# **BID ADDENDUM #2**

July 30, 2024

## **Montecito Fire Protection District Fire Station 92 – Gates and Carport ITB# 2024-002**

NORTH  
ELECTRICAL FLOOR PLAN  
SCALE: 3/16" = 1'-0"

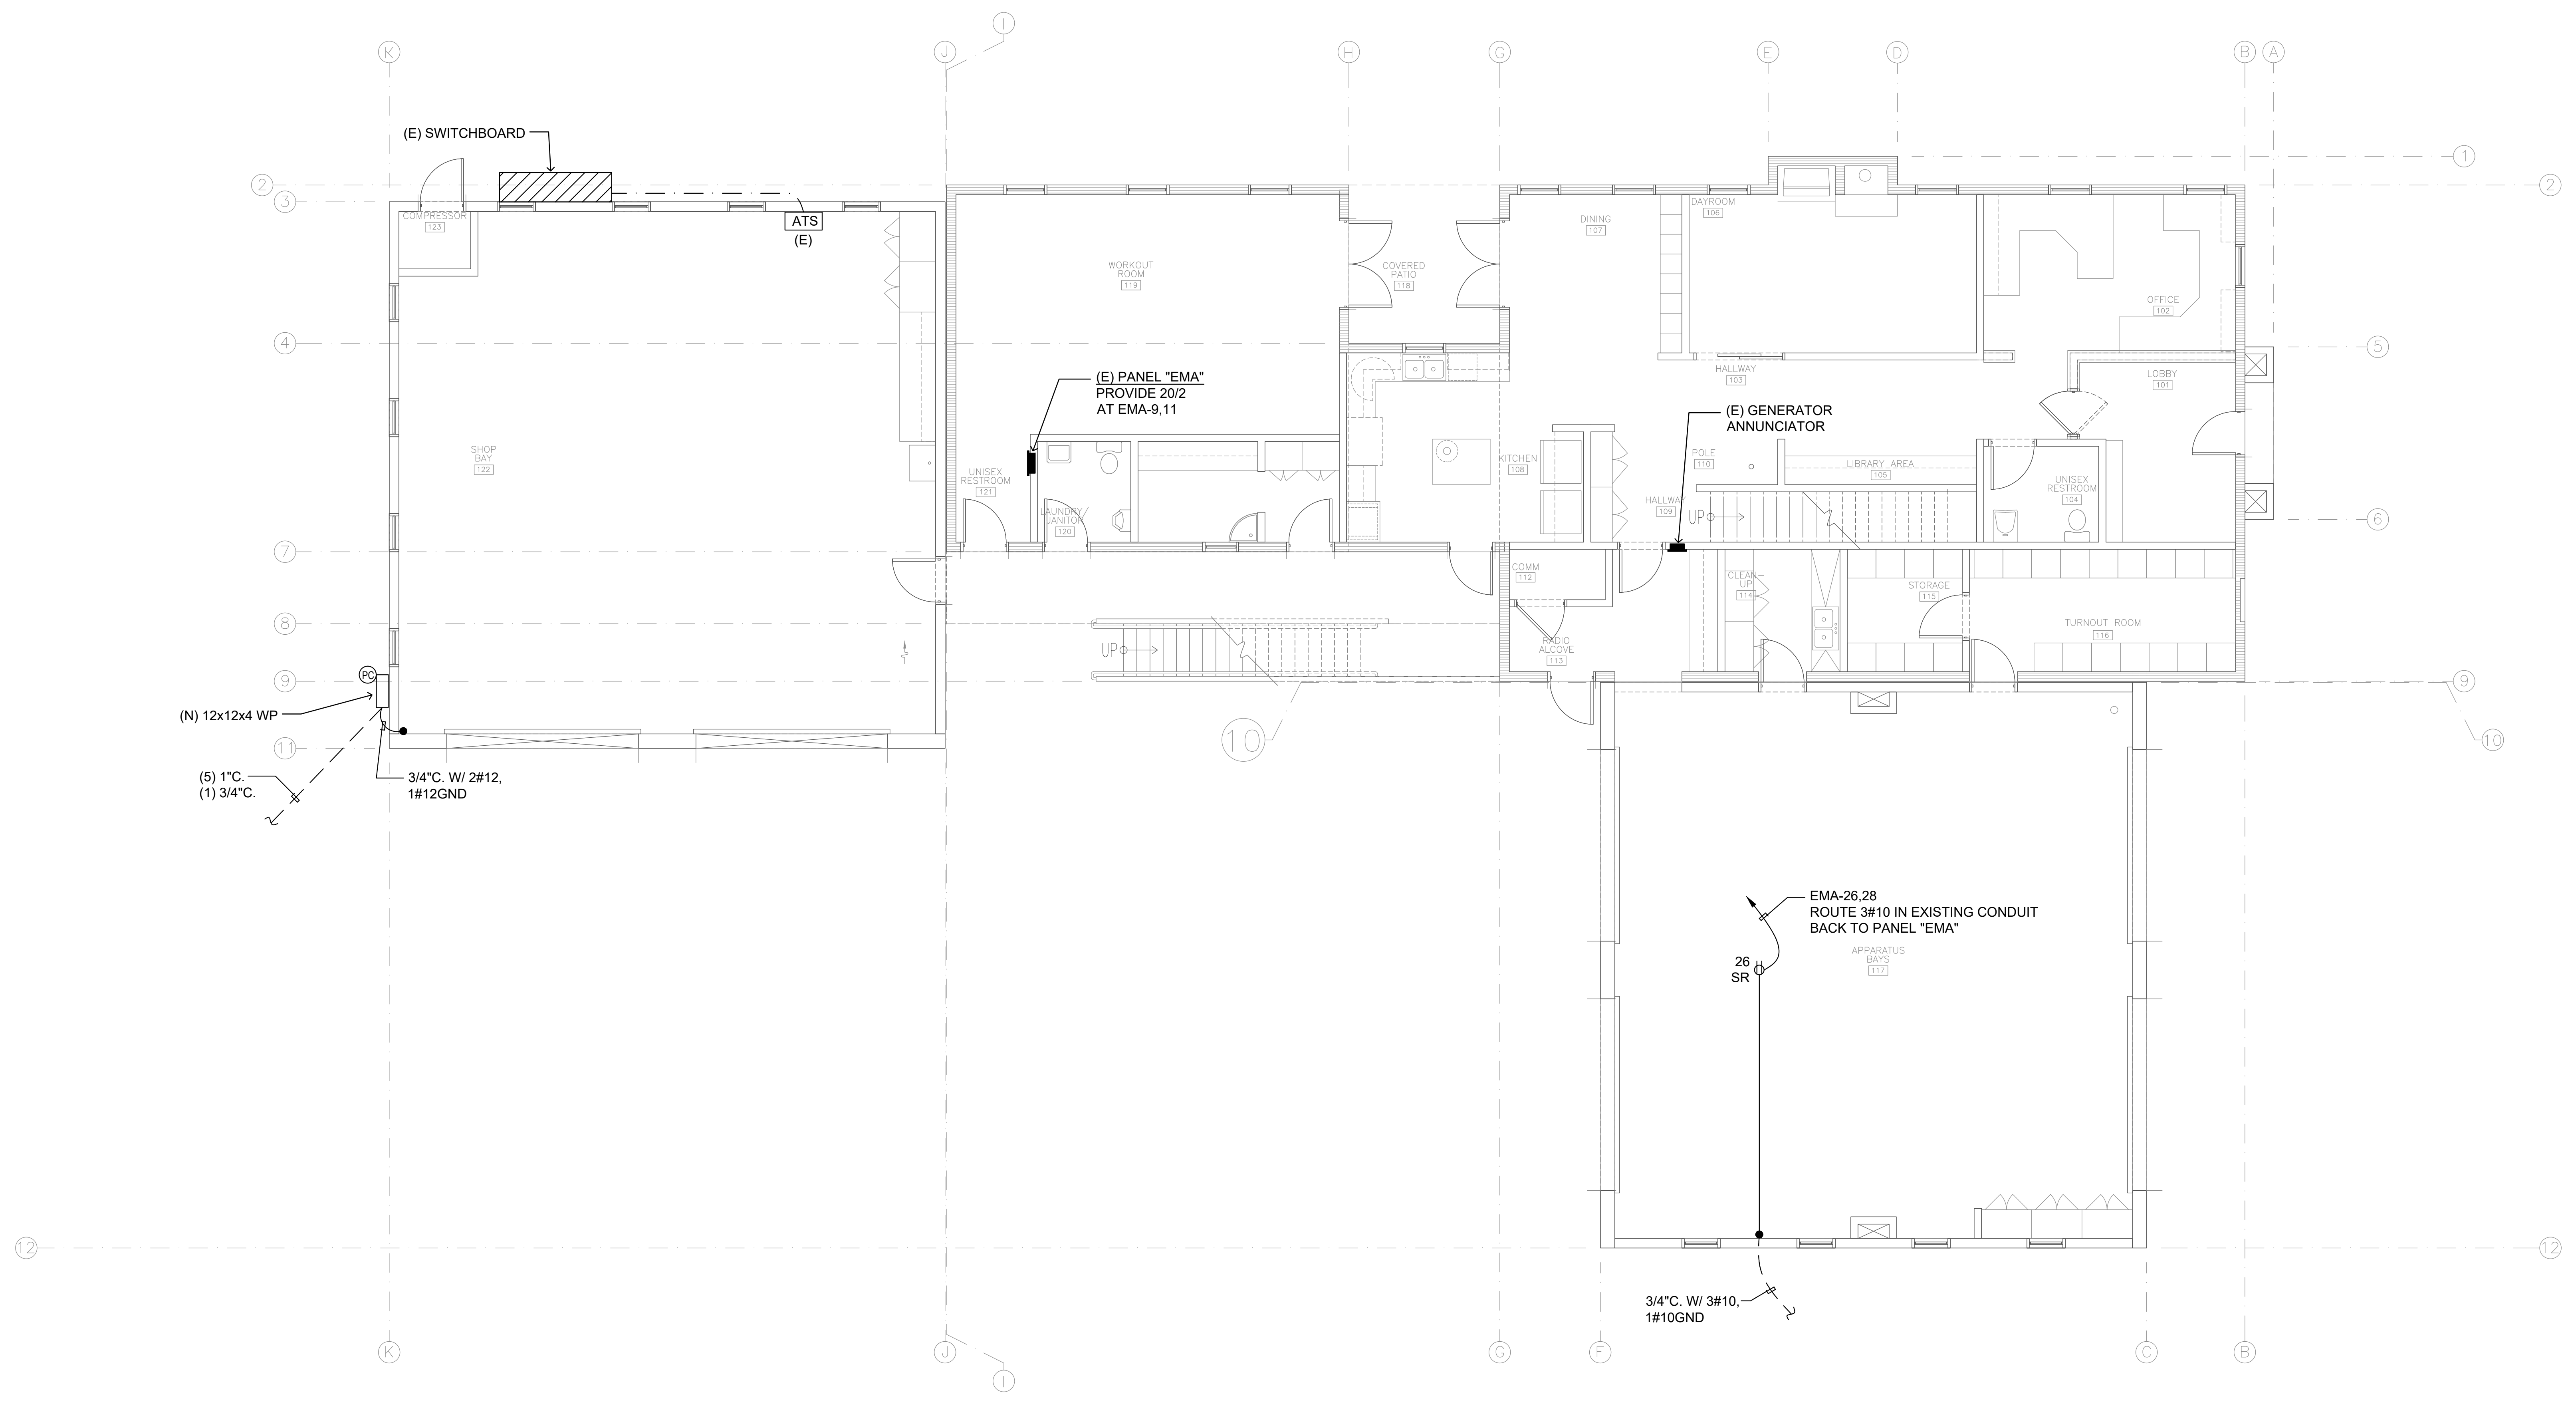
Camera – CAT6 conduit run from Comm 112 for future camera at the gate.

### CARPORIT ELECTRICAL PLAN

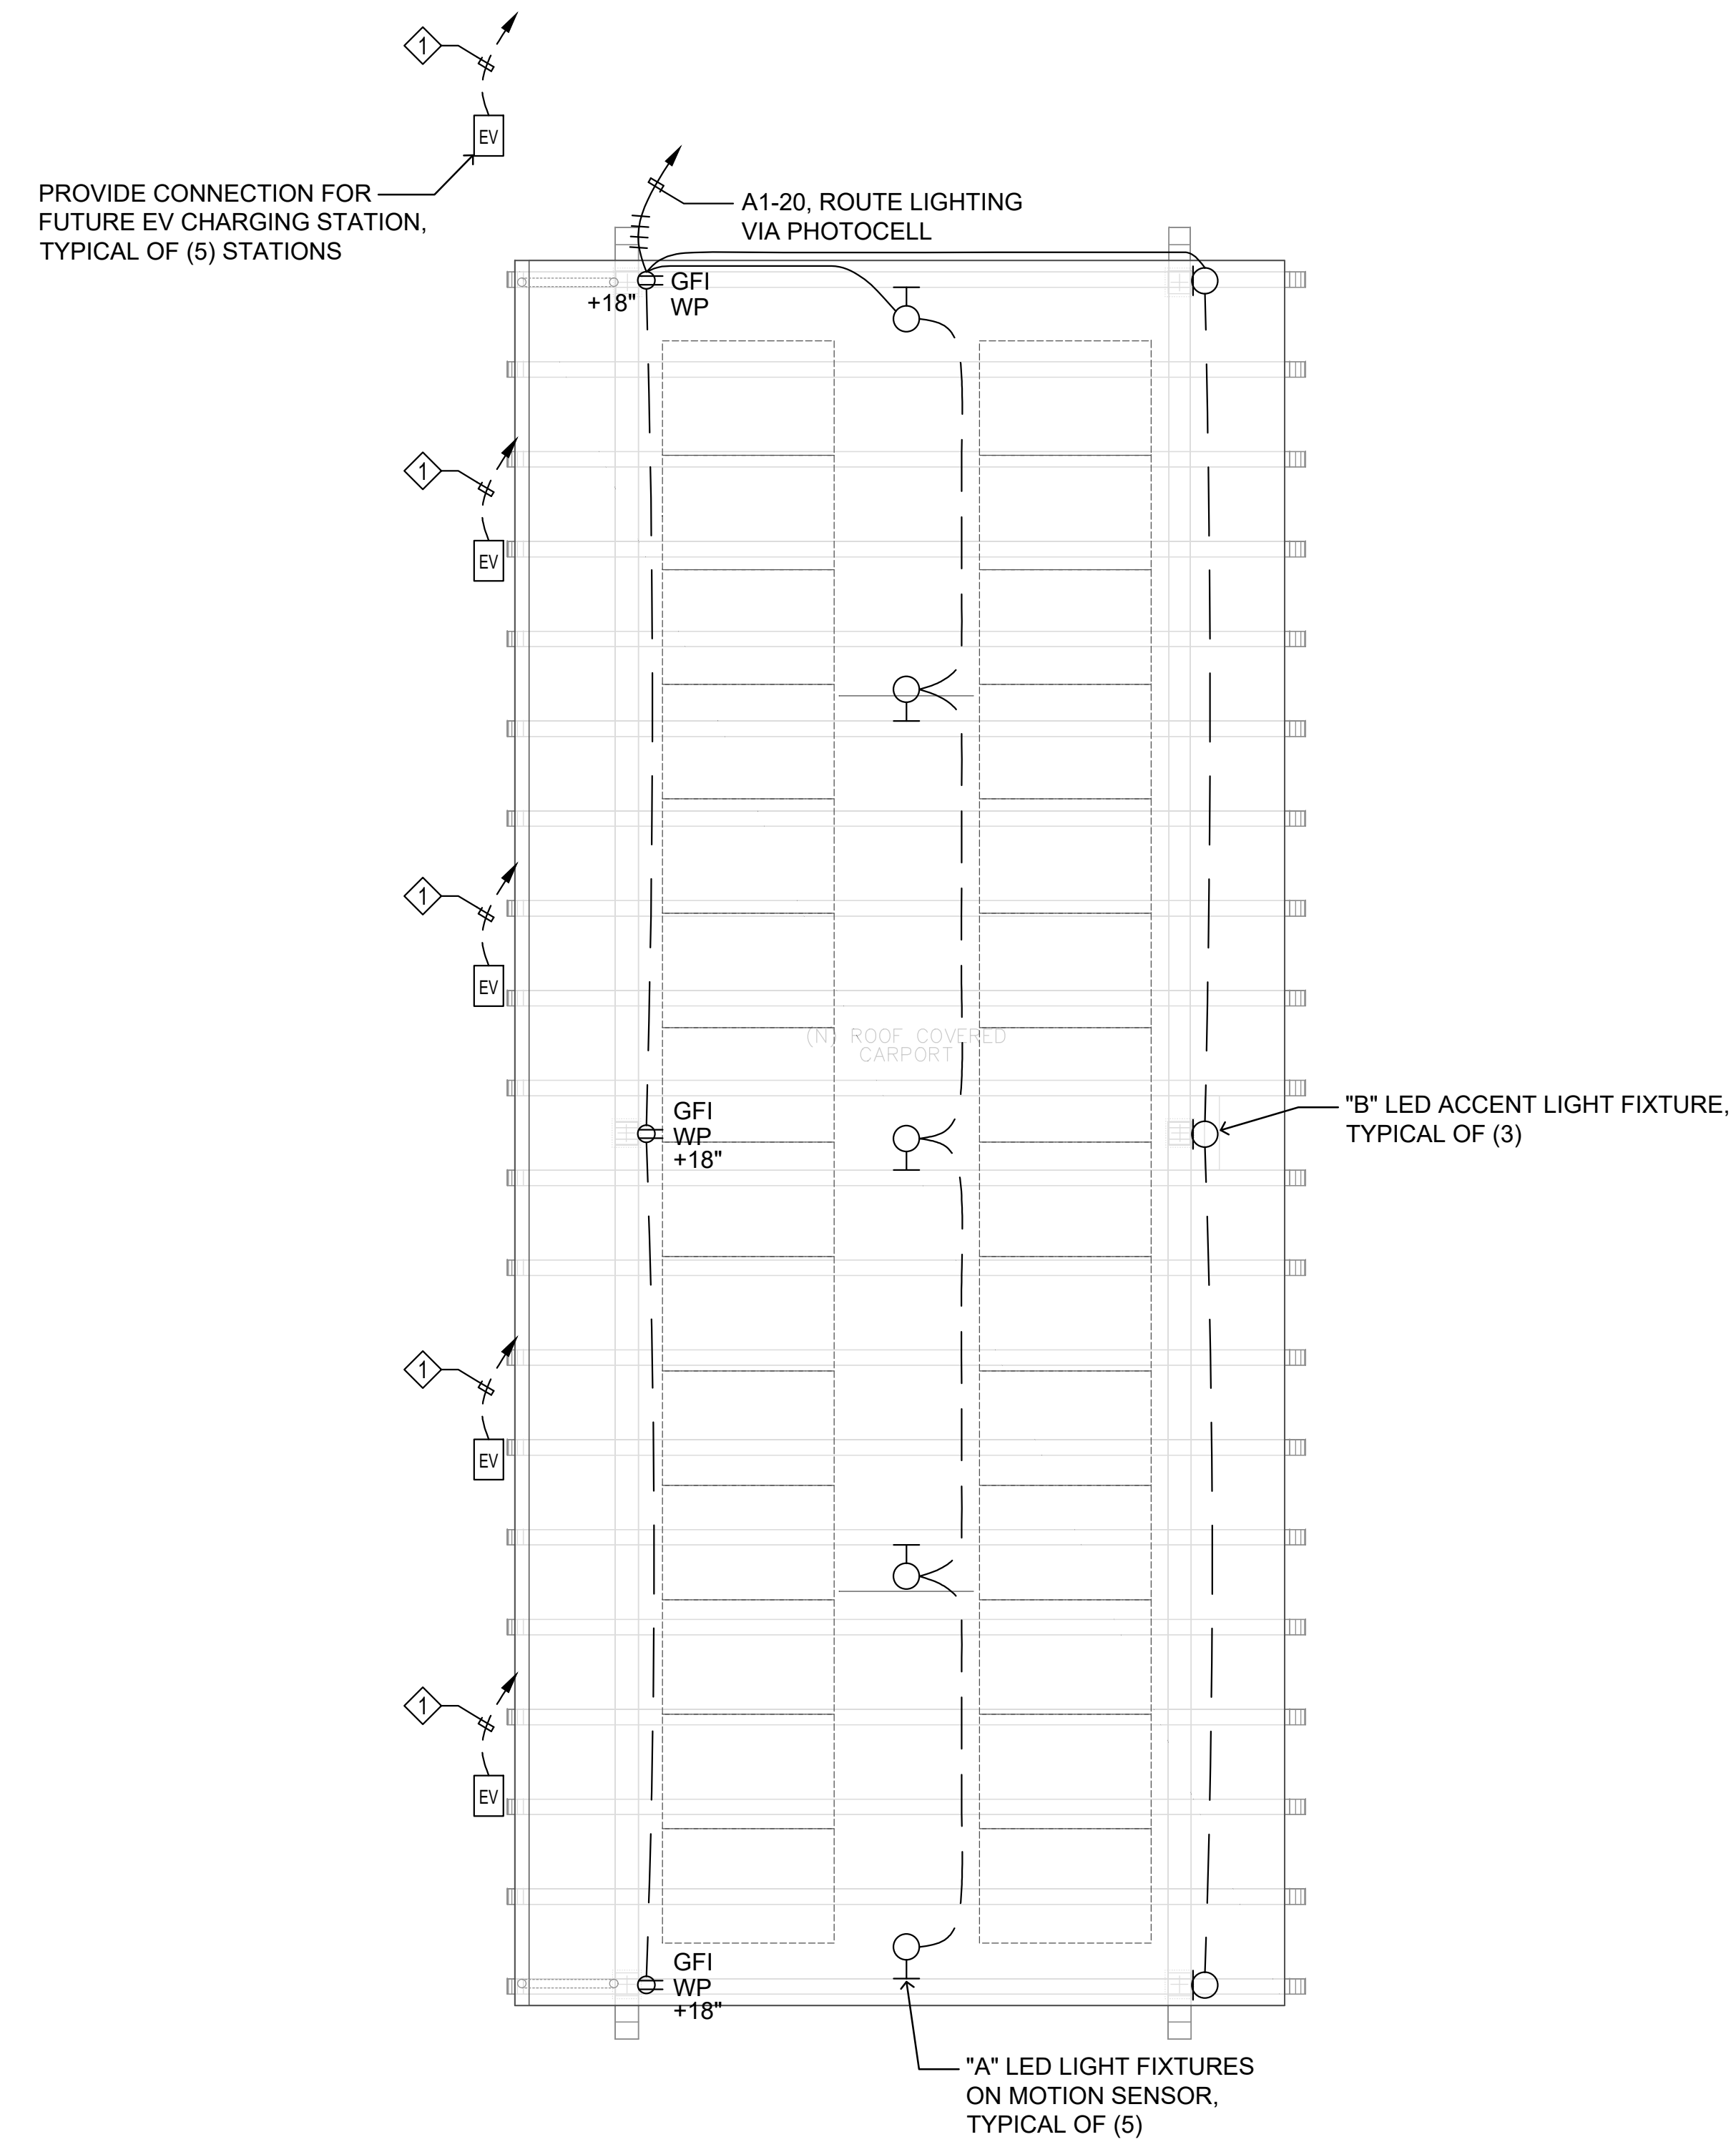
Solar - the electrical plan includes preparatory work for future solar. In addition to what is shown, a 1-1/4" conduit from the carport structure post to the pull box at the building to be installed for future panels on the roof.
